Ref: 2023/(PSIL)BELSKRD2/PSIL/PlanD/RtoC_02

Amendment of Plan to Rezone from “Residential (Group D)” (“R(D)”), “Residential (Group E)” (“R(E)”) and an area shown as ‘Road’ to “Residential (Group C)3) (“R(C)3”) on the Approved Ho Chung Outline Zoning Plan No. S/SK-HC/11 Various Lots in Demarcation District 210 and Demarcation District 244 and Adjoining Government land Ho Chung, Sai Kung, New Territories, Hong Kong

Responses to Comments from Government Departments via Planning Department’s email on 17.10.2023 on the Planning Application No. Y/SK-HC/6 issued on 31.08.2023 (Comments from the Environmental Protection Department were replied on 30.10.2023)

Drawn	HY	Date	03/11/2023	Drawing No.	
Checked	RT	Approved	FW	Fig. 3.3	
Scale	1:5000 @ A3			Rev.	-
Rev	Description	Date

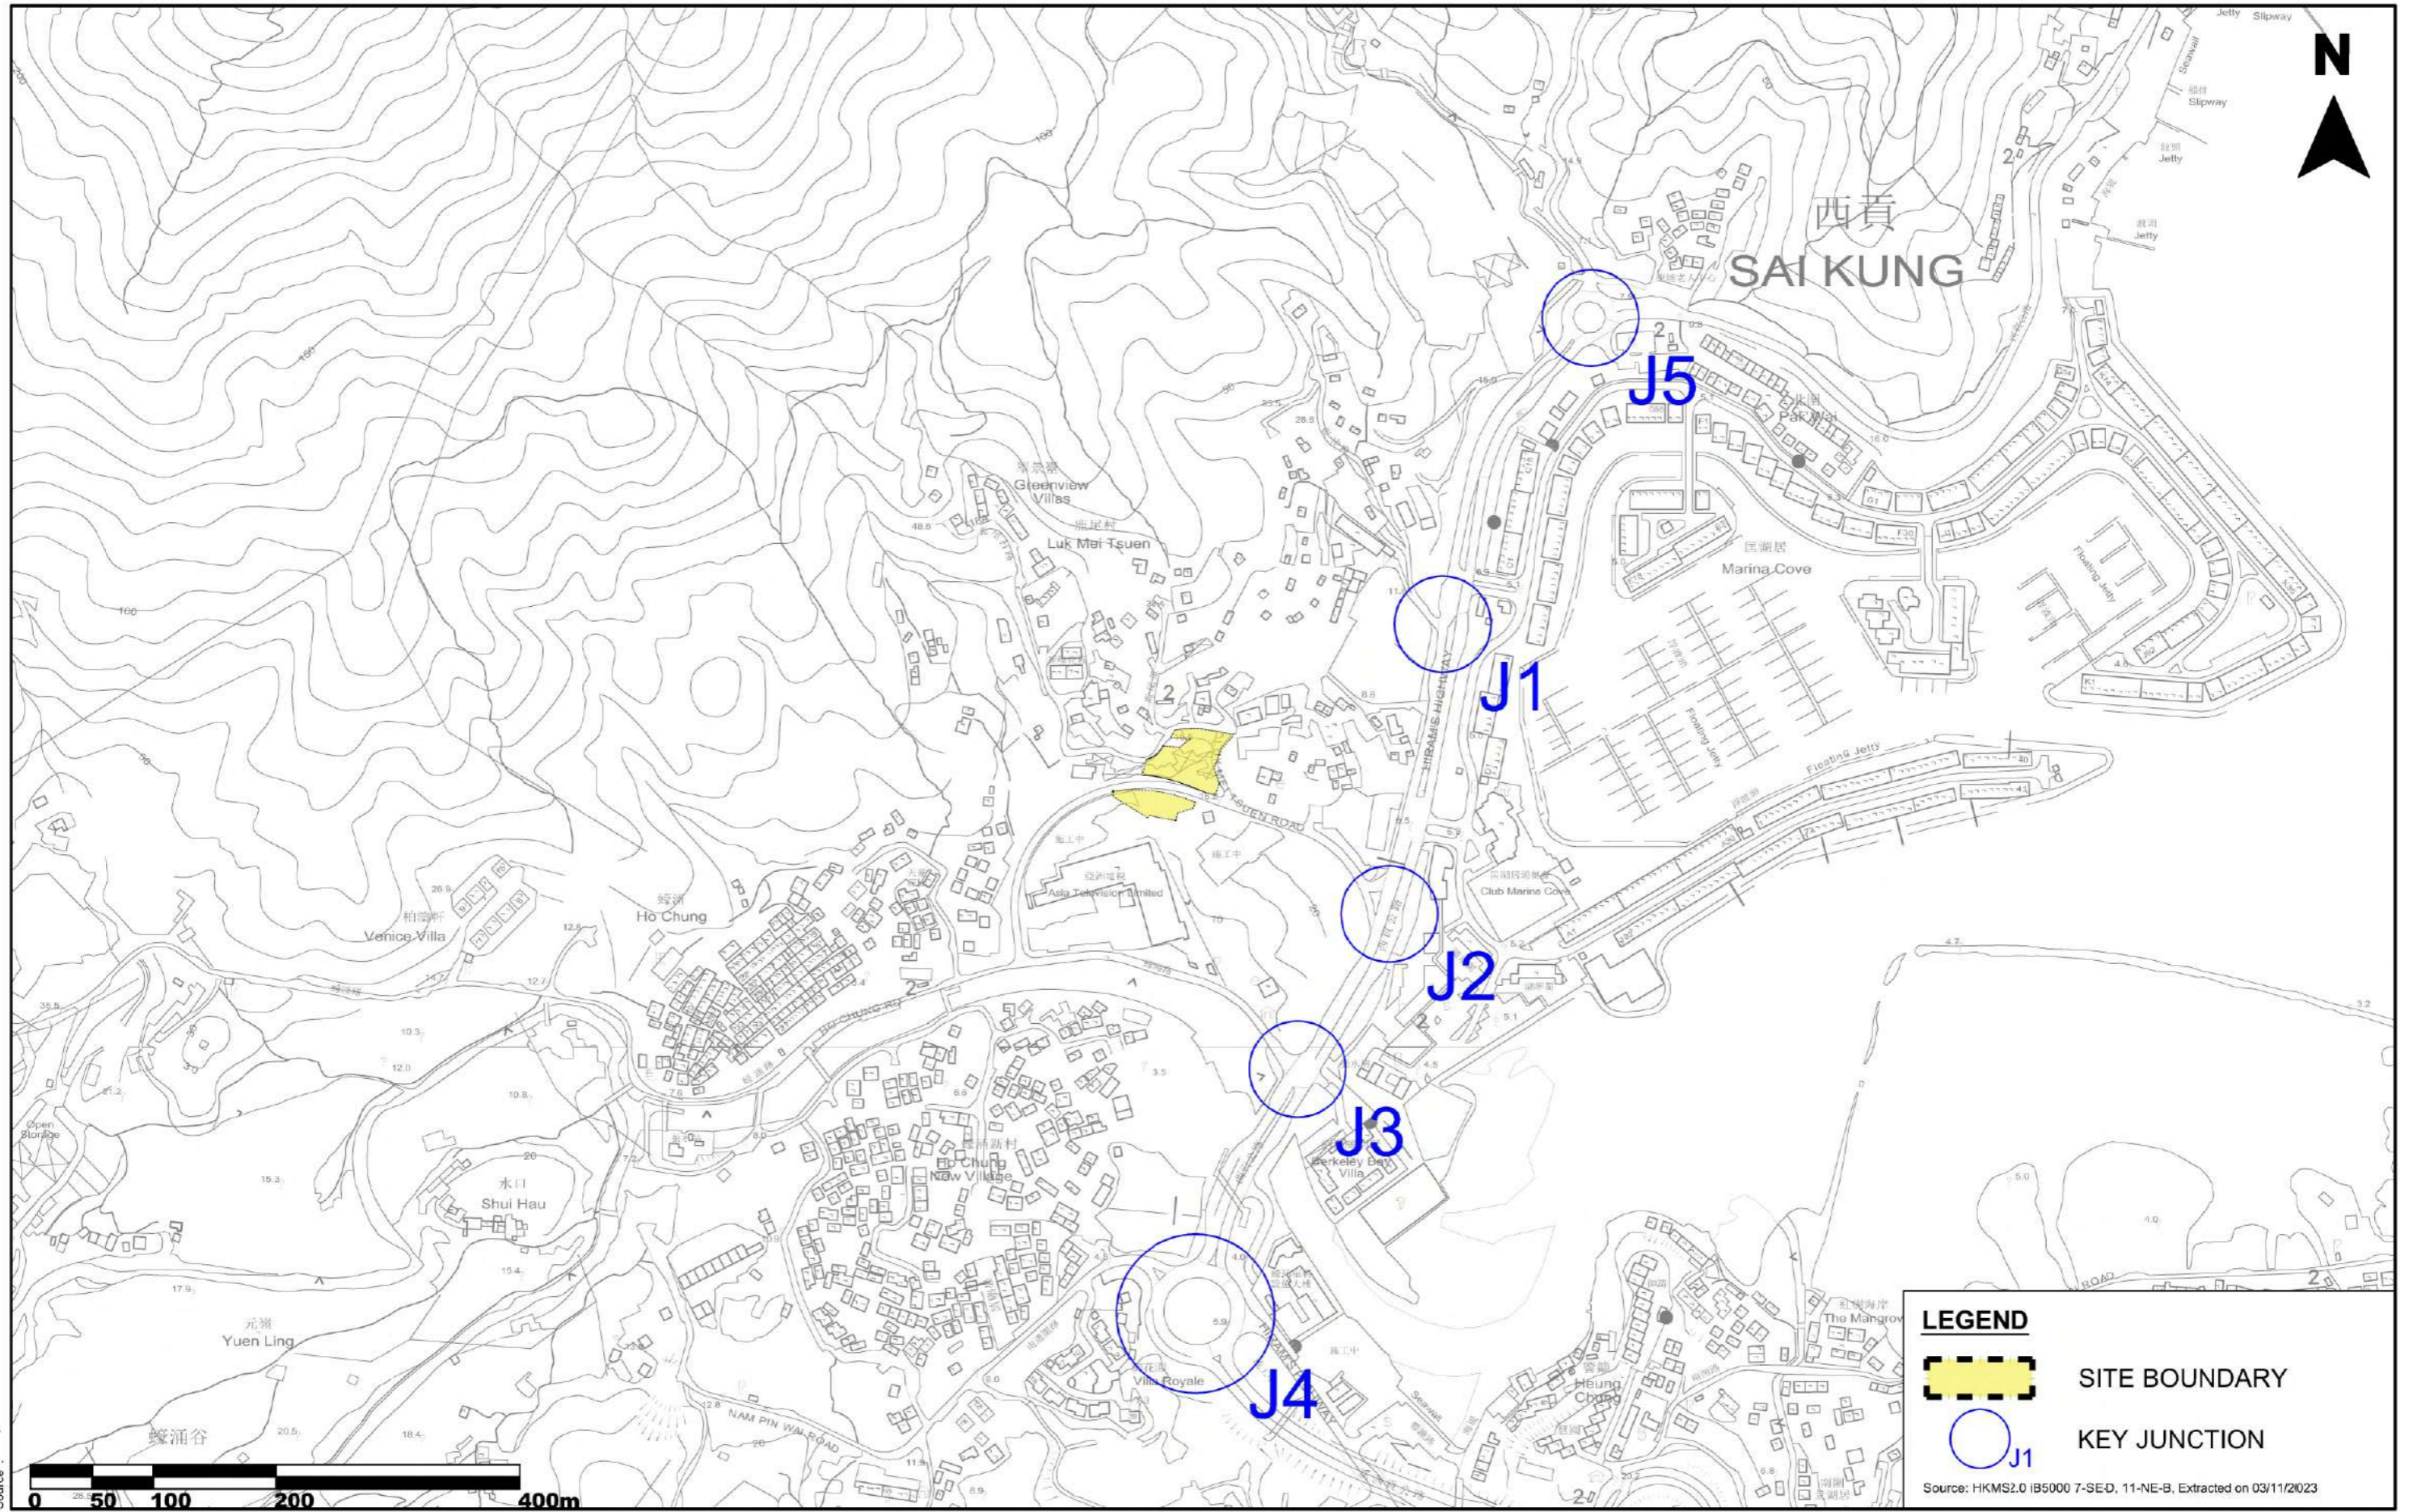
Item	Comments	Responses
TD – TIA1	<u>Section 3.1.3 and Figure 3.3</u> Please include the Pak Wai roundabout in the study.	The Study with Figures are updated with Pak Wai Roundabout and the results showed the proposed site will have no adverse impact to this junction. This has been updated in the Traffic Impact Assessment (Version B) (TIA (Ver. B)) that have been enclosed in this RtoC Table as Attachment 2.
TD – TIA2	<u>Section 3.4.1</u> It is noted that the traffic count survey was carried out in August 2020. Please provide updated traffic count.	The updated traffic count survey was carried out in November 2023 and the findings are adopted in the TIA (Ver. B) that have been enclosed in this RtoC Table as Attachment 2.
TD – TIA3	<u>Section 4.4</u> Please indicate traffic flows generated from planned/committed developments in the vicinity and include in the assessment.	The 2 planned developments within the study area including Application No. A/SK-HC/340 and A/SK-HC/316 are incorporated in the TIA (Ver. B). This has been enclosed in this RtoC Table as Attachment 2.

Drawing No.	Fig. 5.1
Rev.	-

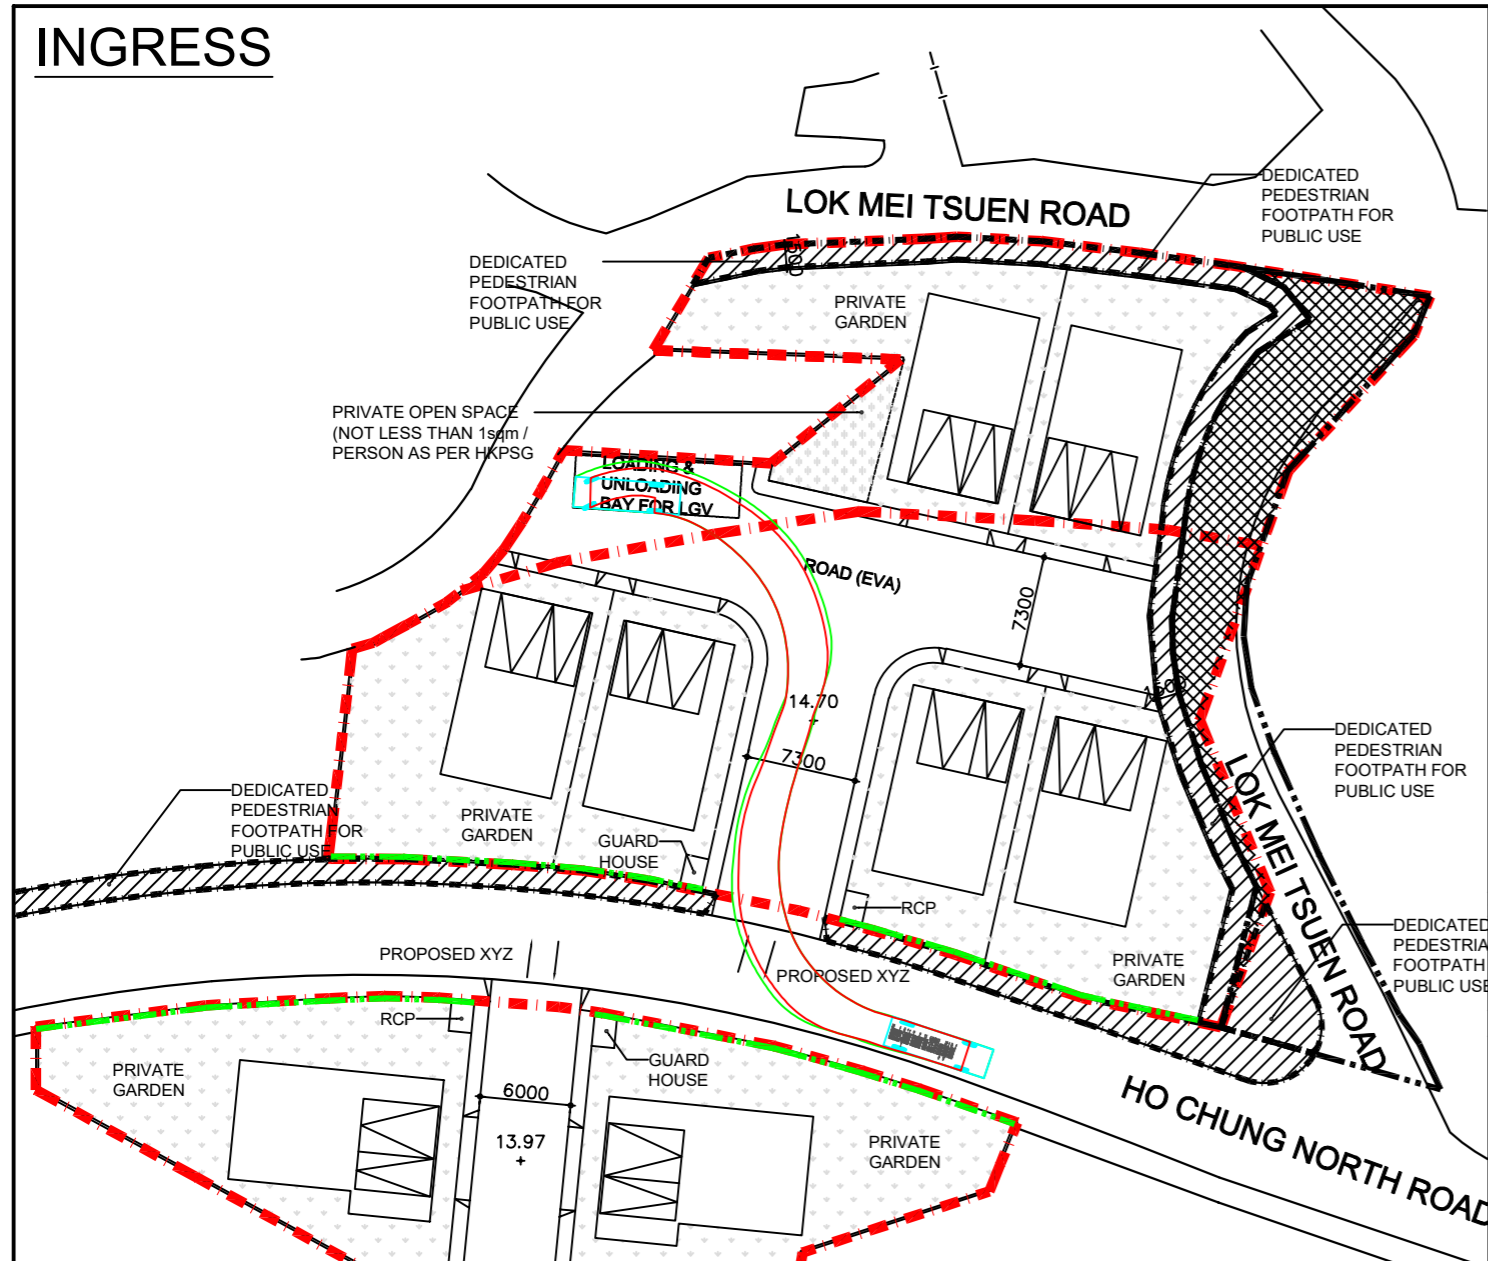
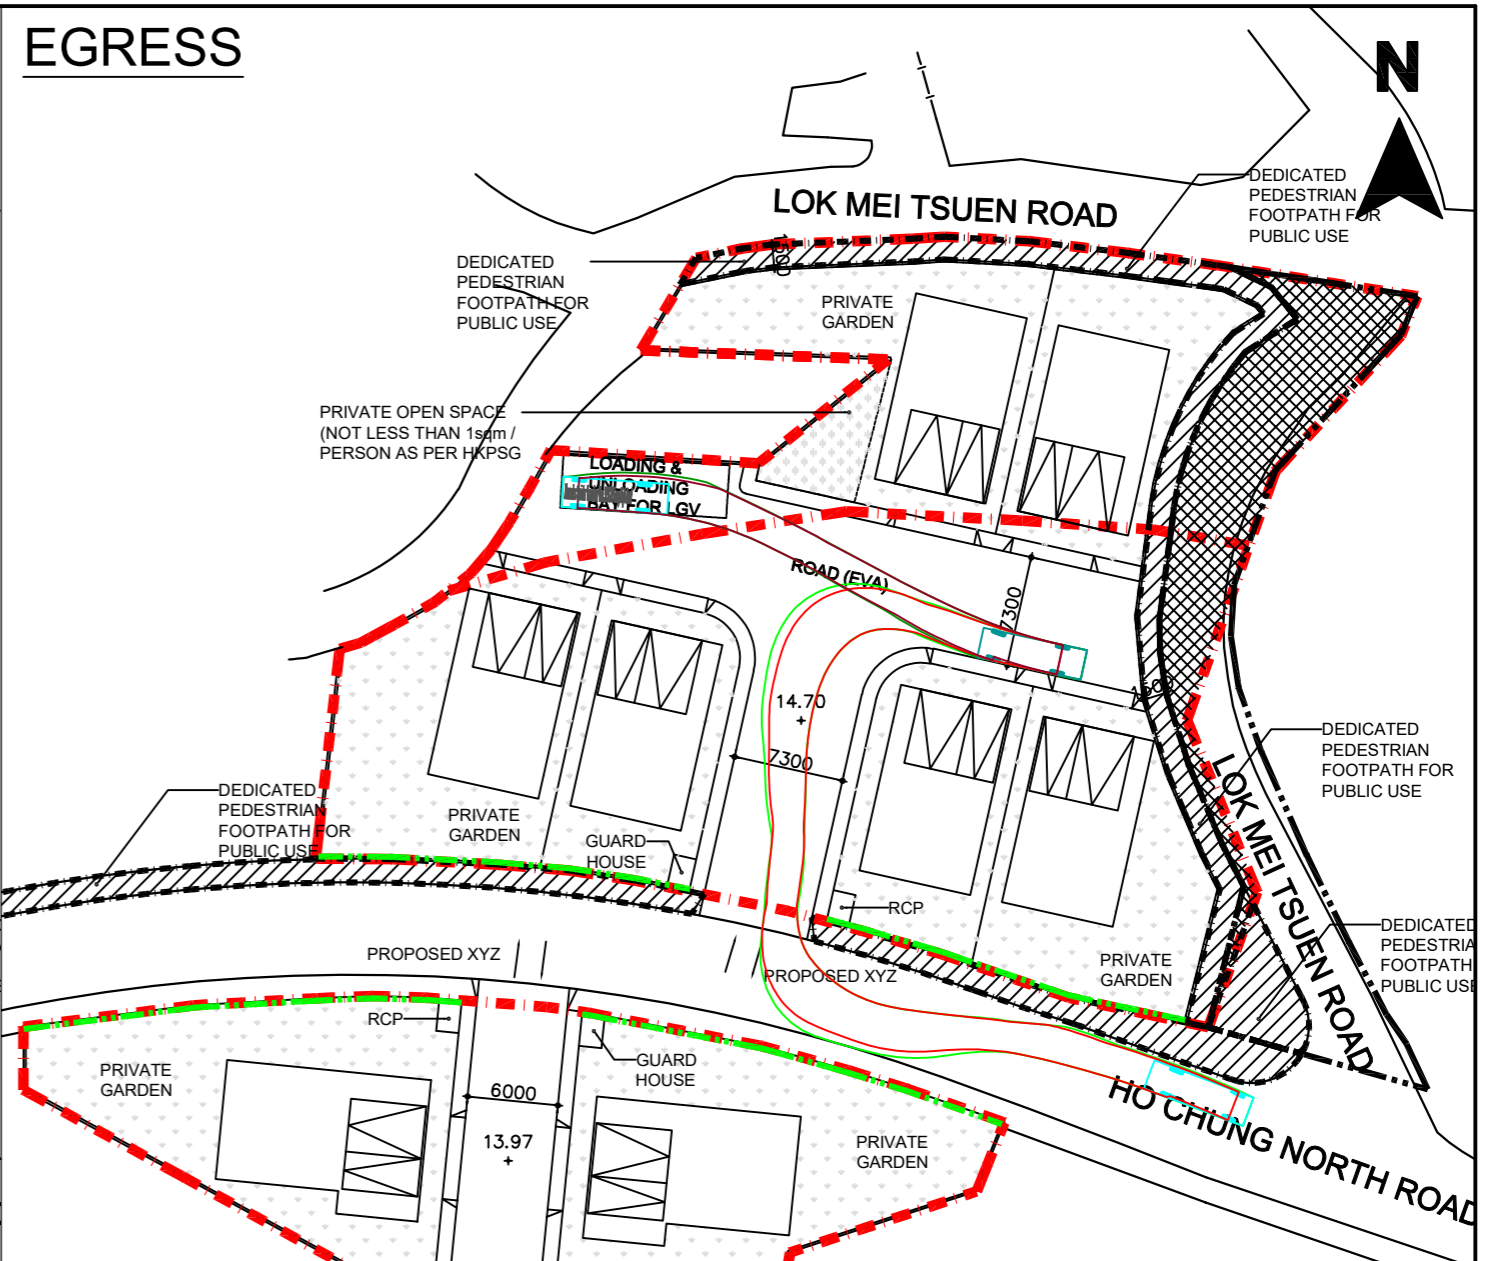
TD – TIA5	<u>Section 5</u> Please provide the internal layout showing the internal transport facilities, including the parking space and loading/unloading area.	Figure 5.1 is updated in the TIA (Ver. B) to show the internal transport facilities, including the parking space and loading/unloading area. This has been enclosed in this RtoC Table as Attachment 2.
TD – TIA6	<u>Figure 5.1</u> Please provide the swept path for vehicular access to the site.	The Swept Path for vehicular access to the site are shown in new Figure 5.2 in the TIA (Ver. B). This has been enclosed in this RtoC Table as Attachment 2.
TD – TIA7	<u>Figure 5.1</u> Please indicate the footpath and vehicular access for public use in Luk Mei Tsuen Road	Figure 5.1 is updated in the TIA (Ver. B) to indicate the footpath and vehicular access for public use in Luk Mei Tsuen Road. This has been enclosed in this RtoC Table as Attachment 2.
